Illinois Tollway Base Sheet Revisions

Section M	Base Sheet Drawings		
	Drawing	Modification Summary	Effective: 03-01-2025
	Roadway (RDY) - Series 400		
	M-RDY-407	EARTHWORK AND GUARDRAIL SCHEDULE

BASE SHEET:  
M-RDY-409

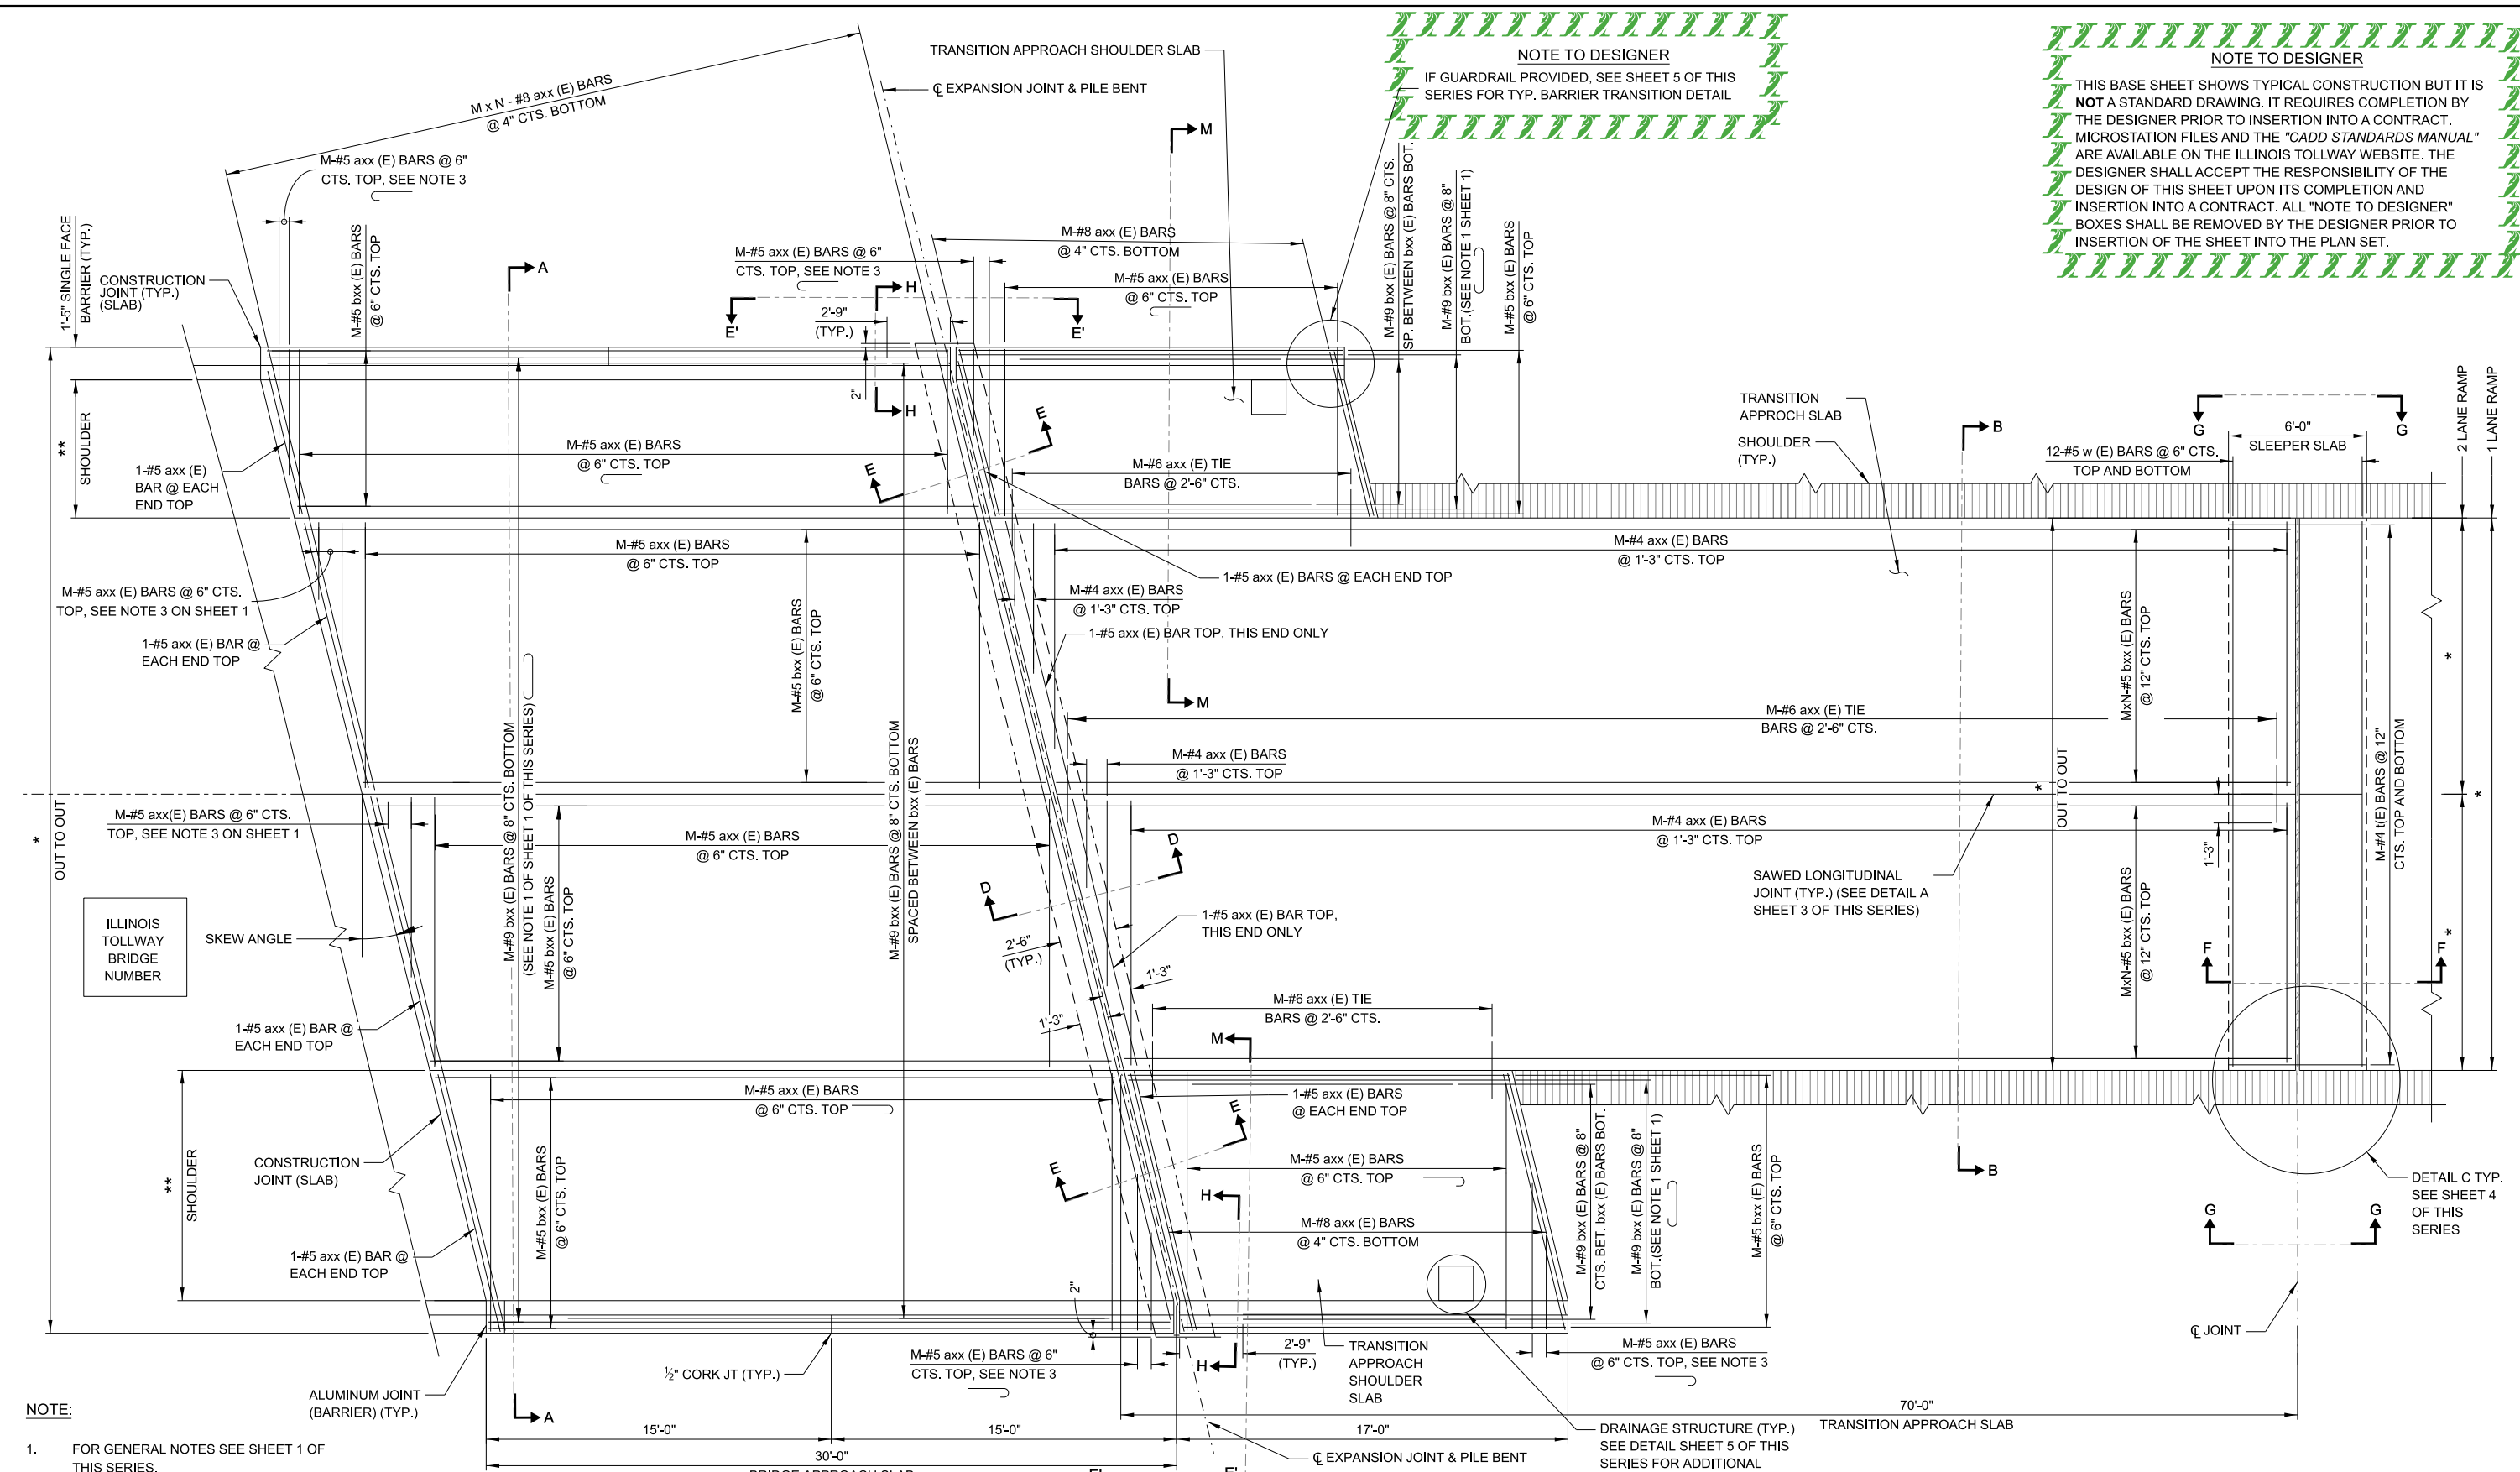
Sheet 3	Added porous granular backfill to the Longitudinal Cross Section similar to SDM Figure 10.3.7.	
	M-RDY-409	APPROACH SLAB, RAMP	
	Sheet 3	Added porous granular backfill to the Longitudinal Cross Section similar to SDM Figure 10.3.7.	
	M-RDY-410	PRECAST APPROACH SLAB W/CIP TRANSITION SLAB

MAINLINE TOLL PLAZA  
PAVEMENT MARKING DETAILS

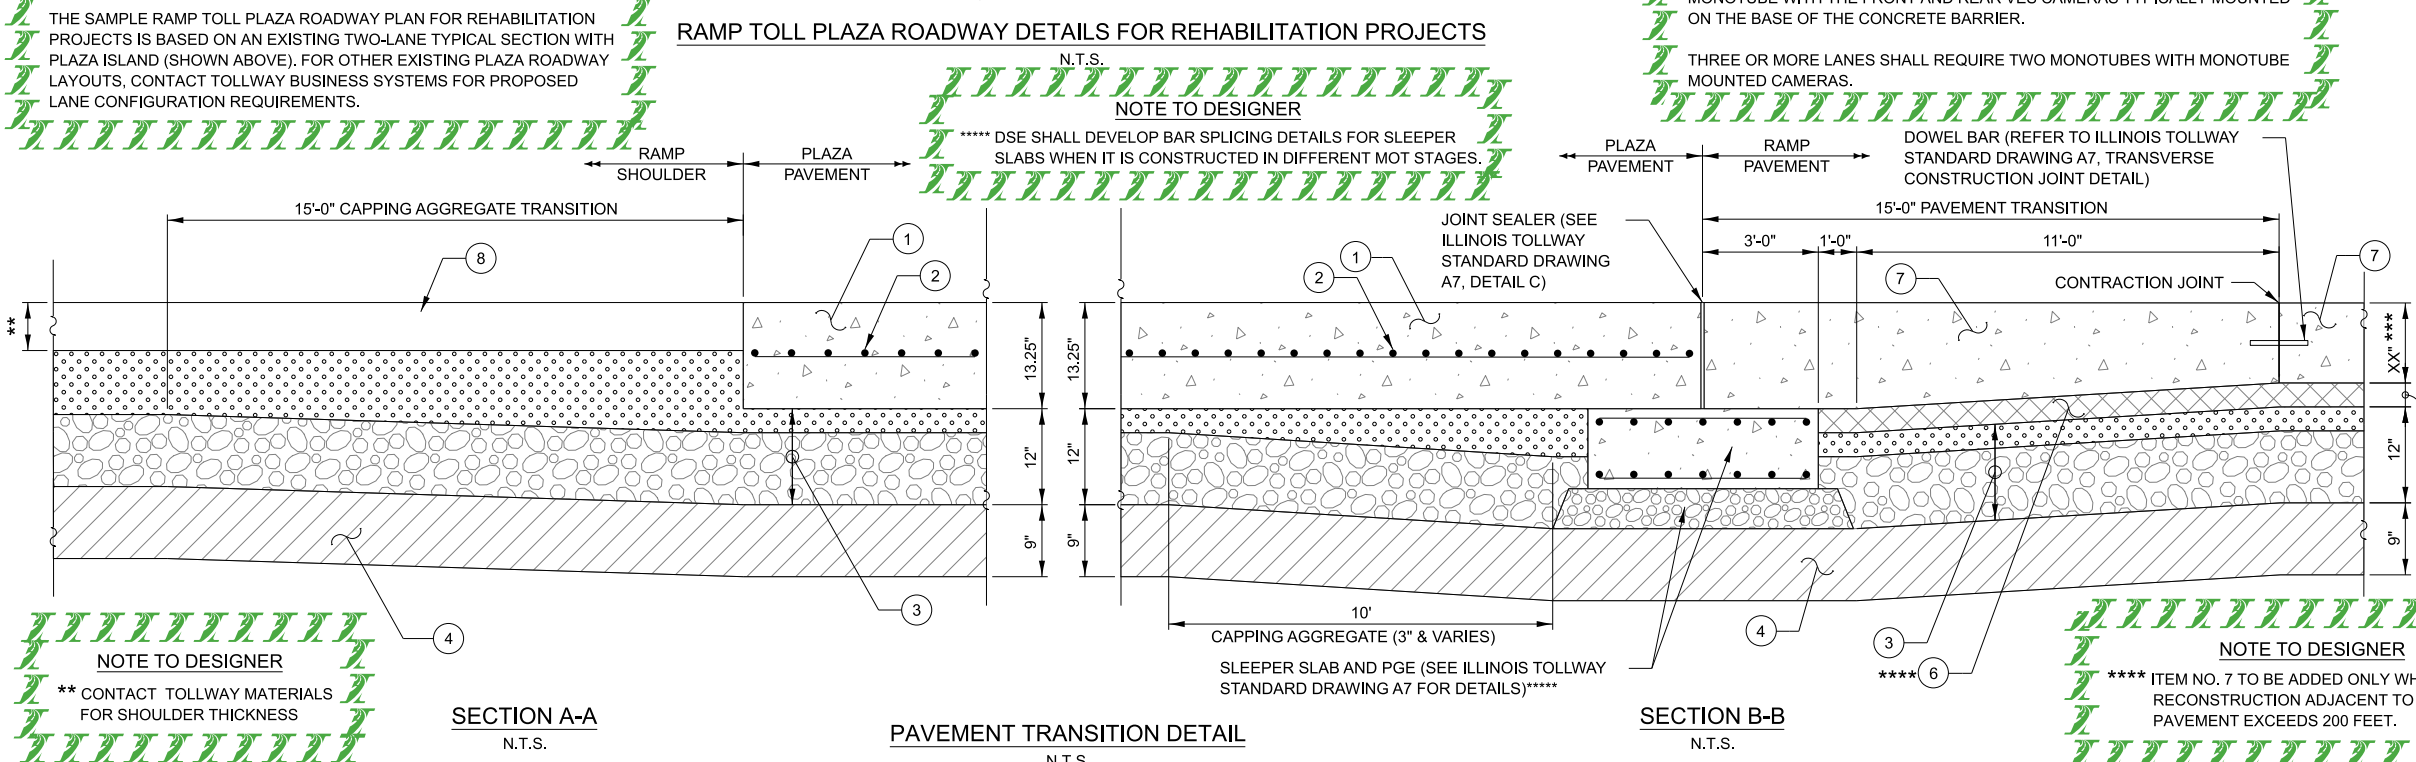
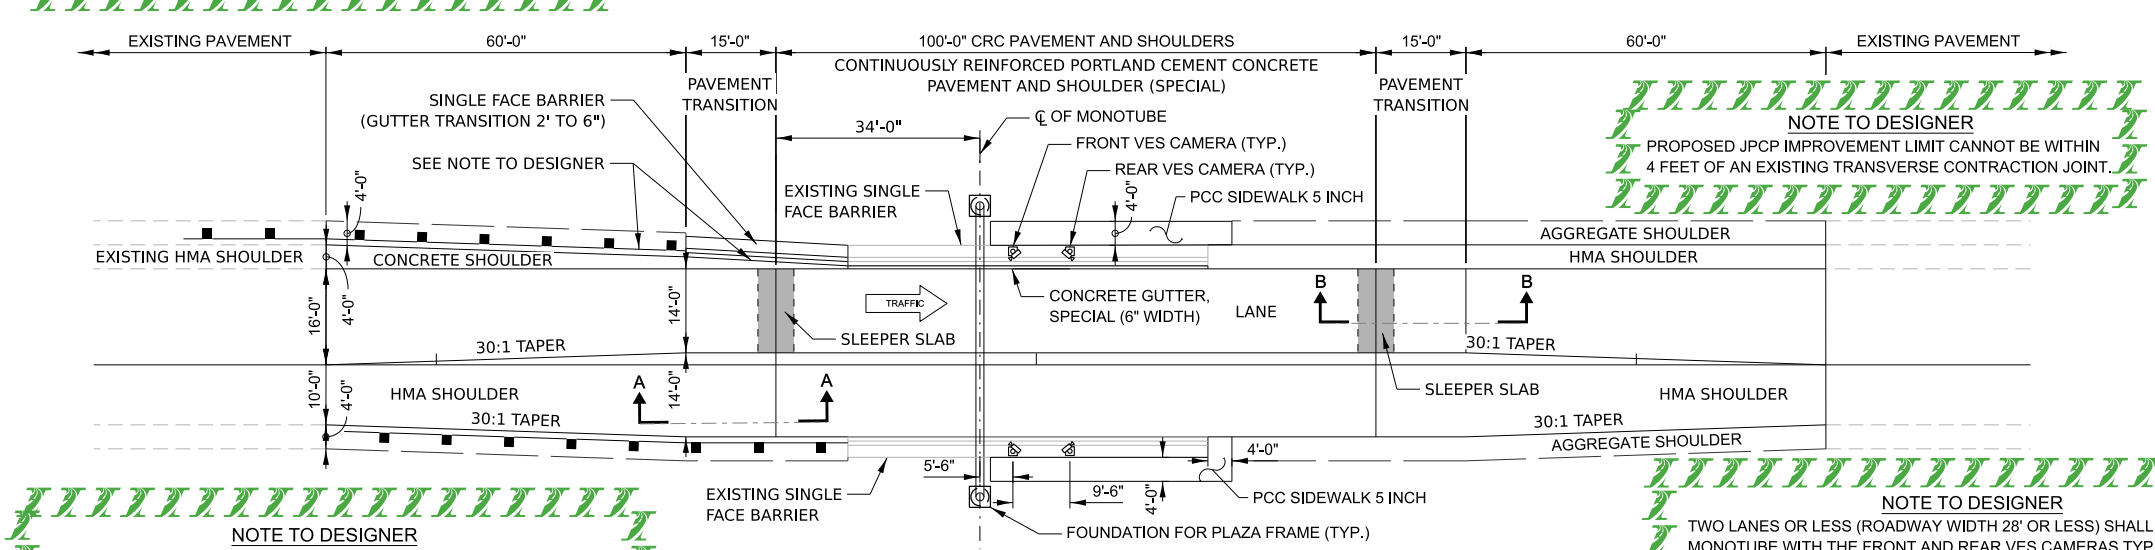
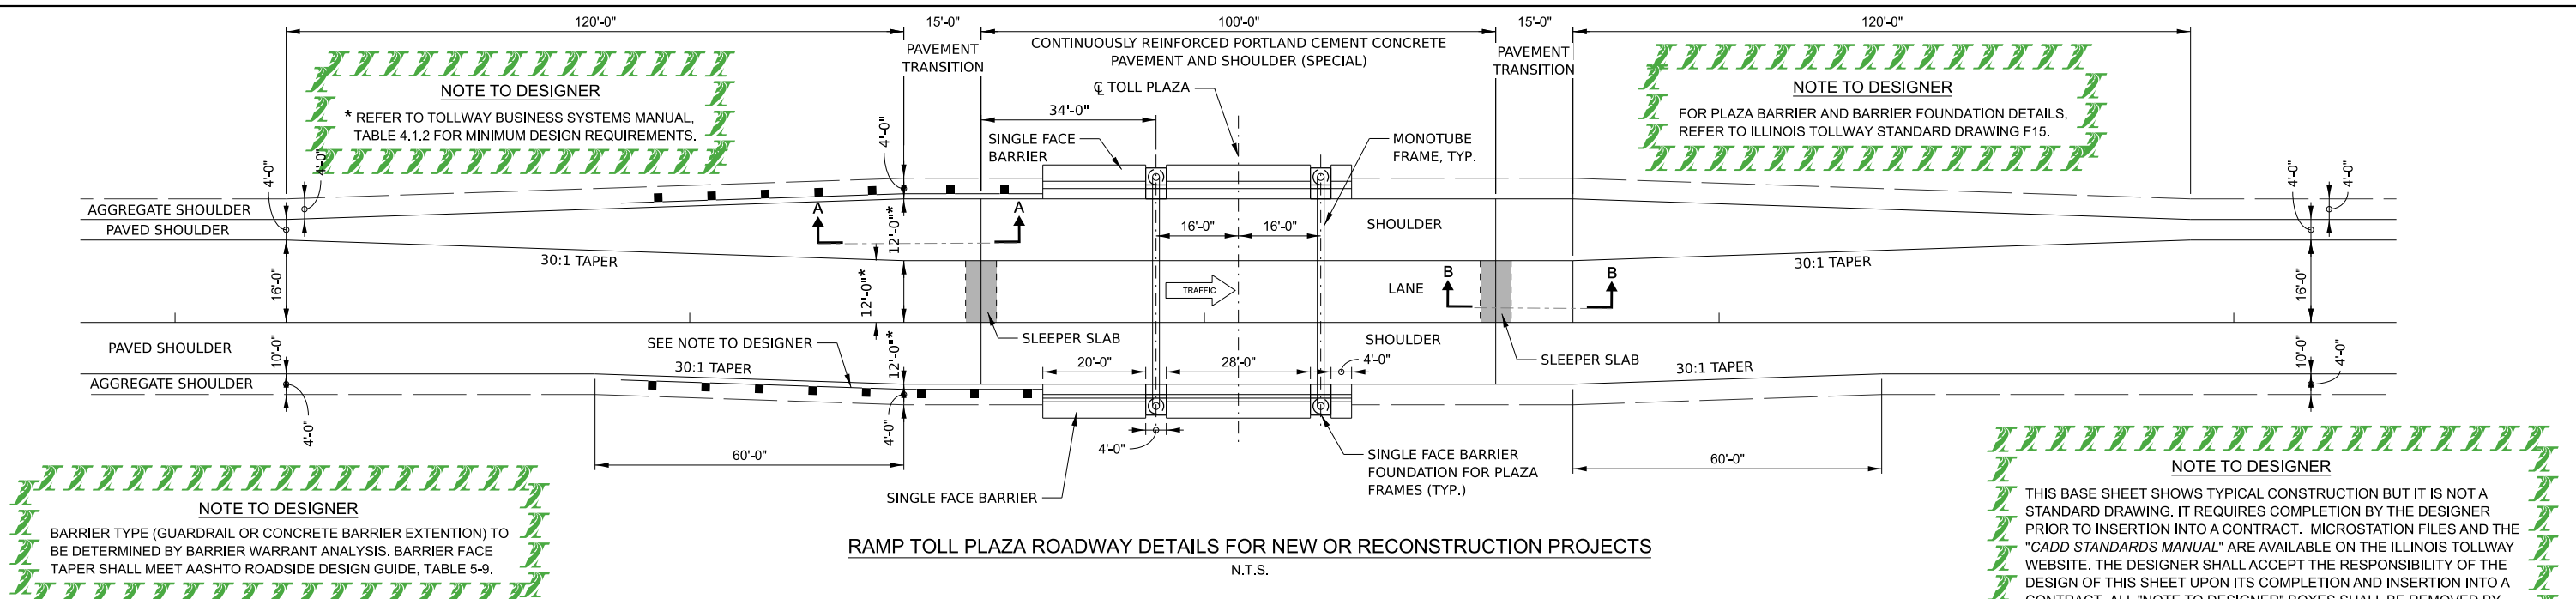
Sheet 3	Added pavement marking details for the pavement area that is in proximity to the Quantum Loop System. Added 'Note to Designer' for loop and conduit layout dimensions.	
	M-RDY-418	RAMP TOLL PLAZA PAVEMENT DETAILS

DETAIL A  
PAVEMENT MARKING IN THE  
VICINITY OF PIEZO STRIPS

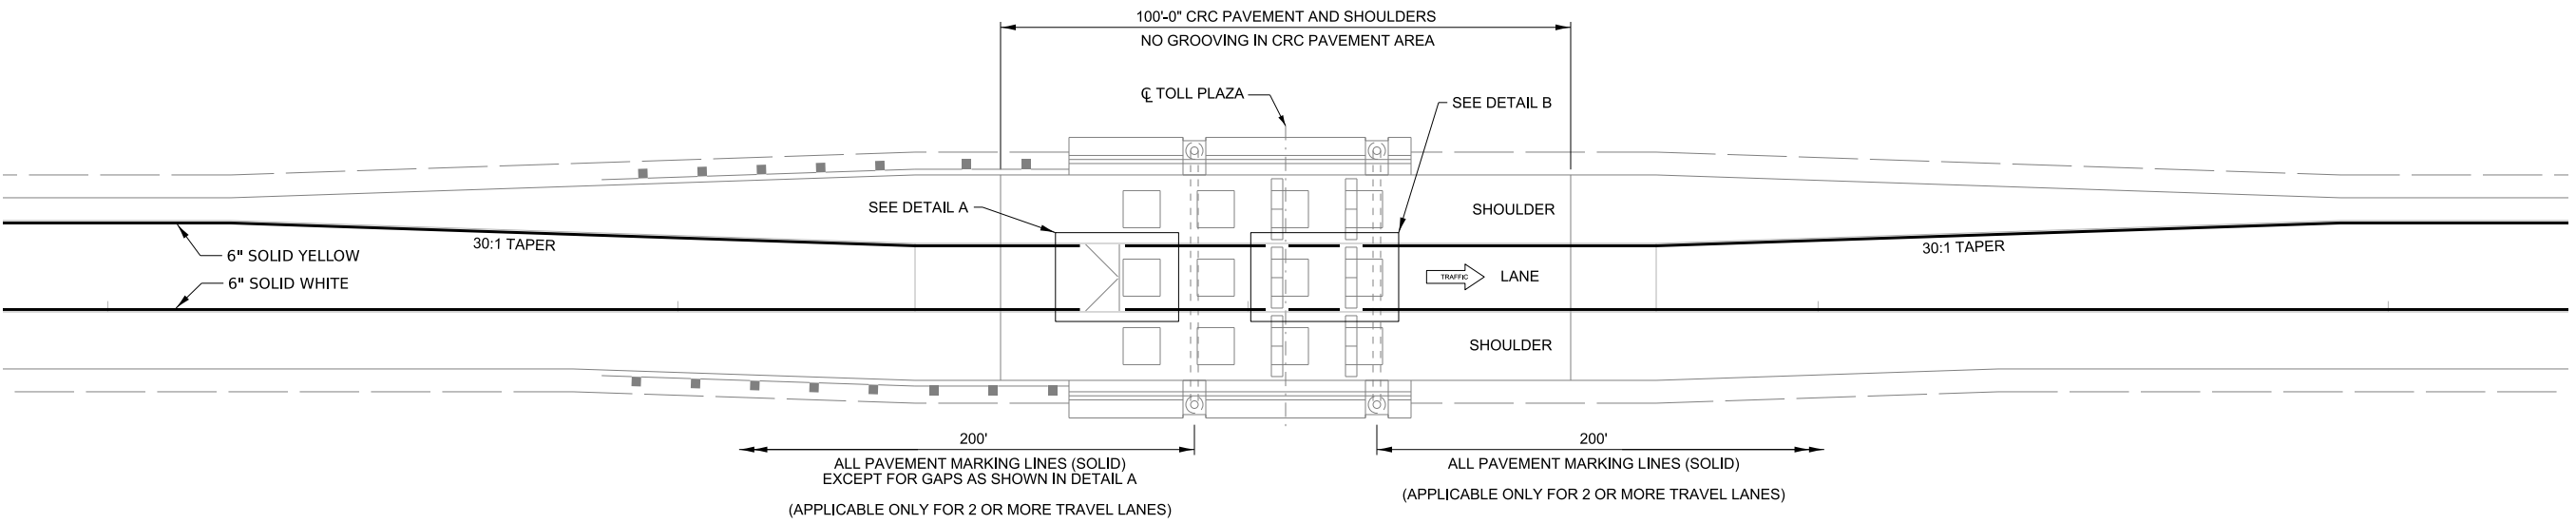
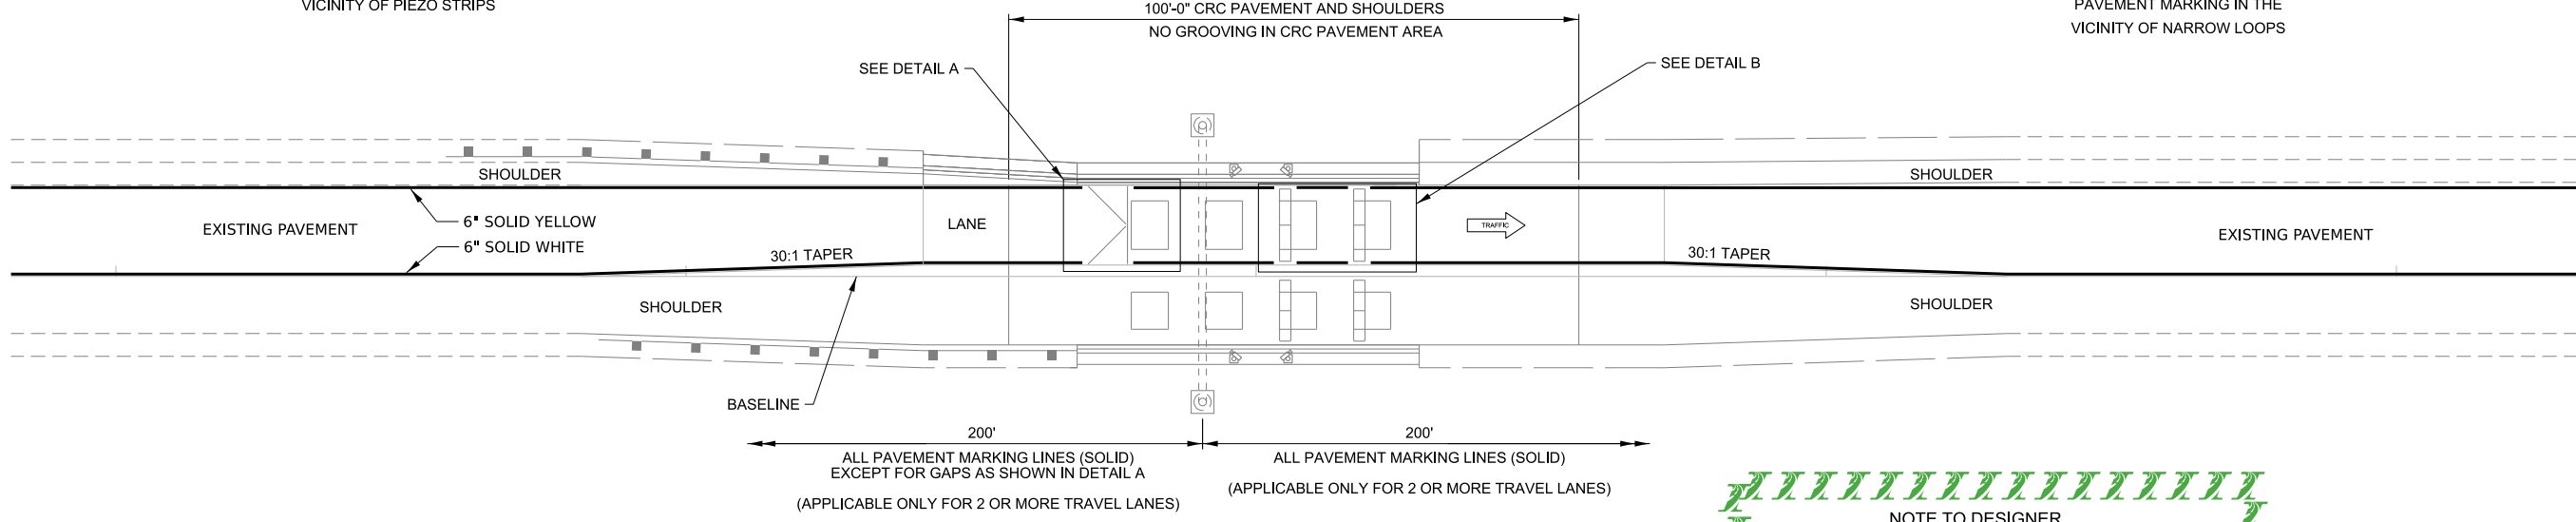
Sheet 2	Removed 'Subgrade Filter Fabric (JI282010)' from pavement details.	
	Sheet 3	Added pavement marking details for the pavement area that is in proximity to the Quantum Loop System. Added 'Note to Designer' for loop and conduit layout dimensions.
